CPSES-2000600390
Log # TXX-06038
File # 00236

**SUBJECT: COMANCHE PEAK STEAM ELECTRIC STATION (CPSES)
DOCKET NOS. 50-445 AND 50-446
LICENSE AMENDMENT REQUEST (LAR) 06-001
REVISION TO TECHNICAL SPECIFICATION 1.1, "DEFINITIONS"
and 3.4.16, "RCS SPECIFIC ACTIVITY"**

ATTACHMENT 1 to TXX-06038
DESCRIPTION AND ASSESSMENT

Figure 3.4.16-1 (page 1 of 1)
Reactor Coolant DOSES EQUIVALENT I-131 Specific Activity
Limit Versus Percent of RATED THERMAL POWER

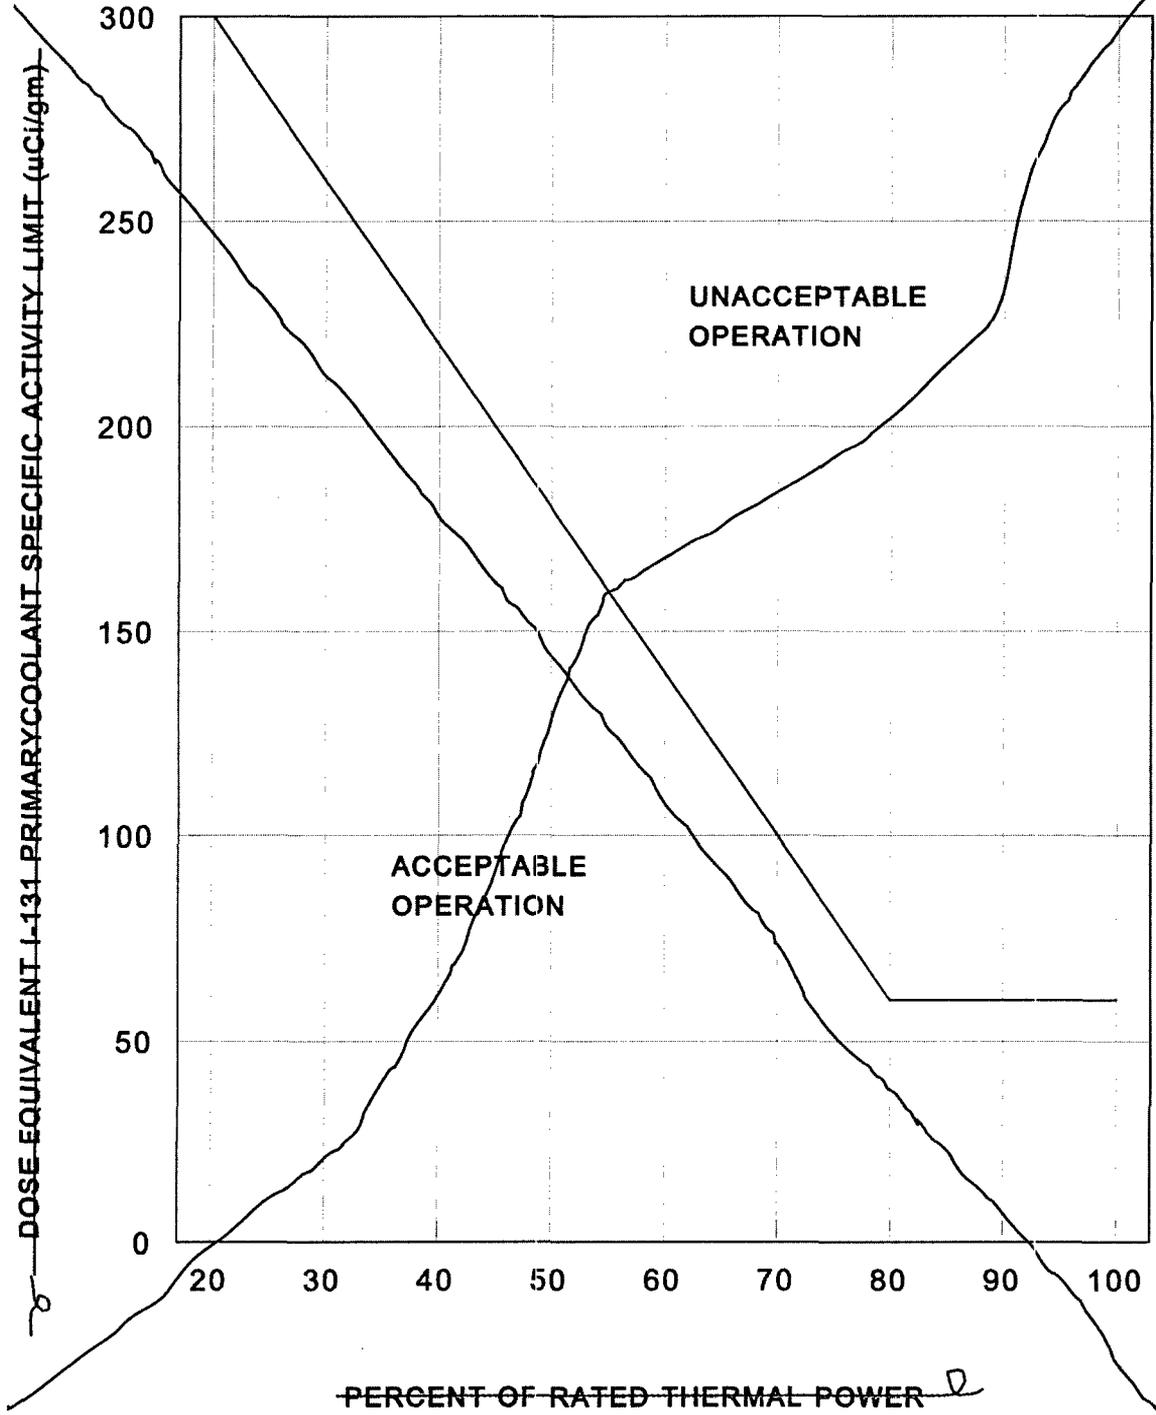
- 2.4 Delete the current TS Figure 3.4.16-1, "Reactor Coolant DOSE EQUIVALENT I-131 Specific Activity Limit Versus Percent of RATED THERMAL POWER".
- 2.5 Revise the Applicability of TS 3.4.16 from:

TS 3.4.16 Required Action A.1 is modified to remove the reference to Figure [3.4.16-1] and insert a limit of less than or equal to $60 \mu\text{Ci/gm}$ for DEI.

The curve contained in Figure [3.4.16-1] was initiated by the AEC in a June 12, 1974 letter from the AEC on the subject, "Proposed Standard Technical Specifications for Primary Coolant Activity." However, this letter does not provide any technical basis for the curve.

The Case 2 radiological consequence analyses for SGTR and MSLB accidents that take into account the pre-accident iodine spike do not consider the elevated RCS iodine specific activities permitted by current TS Figure [3.4.16-1] for operation at power levels below 80% RTP (i.e., DEI of $60 \mu\text{Ci/gm}$ at 80% RTP increasing linearly to $[300] \mu\text{Ci/gm}$ at $[20]\%$ RTP). Instead, the Case 2 analyses assume a DEI concentration 60 times higher than the corresponding accident's Case 1 analysis assumption, [which corresponds to the $60 \mu\text{Ci/gm}$ specific

activity limit associated with 100% RTP operation as discussed in Section 3.1 above.] Therefore, TS 3.4.16 Required Action A.1 should be based on a limit of 60 $\mu\text{Ci}/\text{gm}$ to be consistent with the assumptions contained in the radiological consequence analyses. It is not expected that plant operation at reduced power levels would result in iodine specific activity levels that exceed the 60 $\mu\text{Ci}/\text{gm}$ upper limit defined for full power operation.
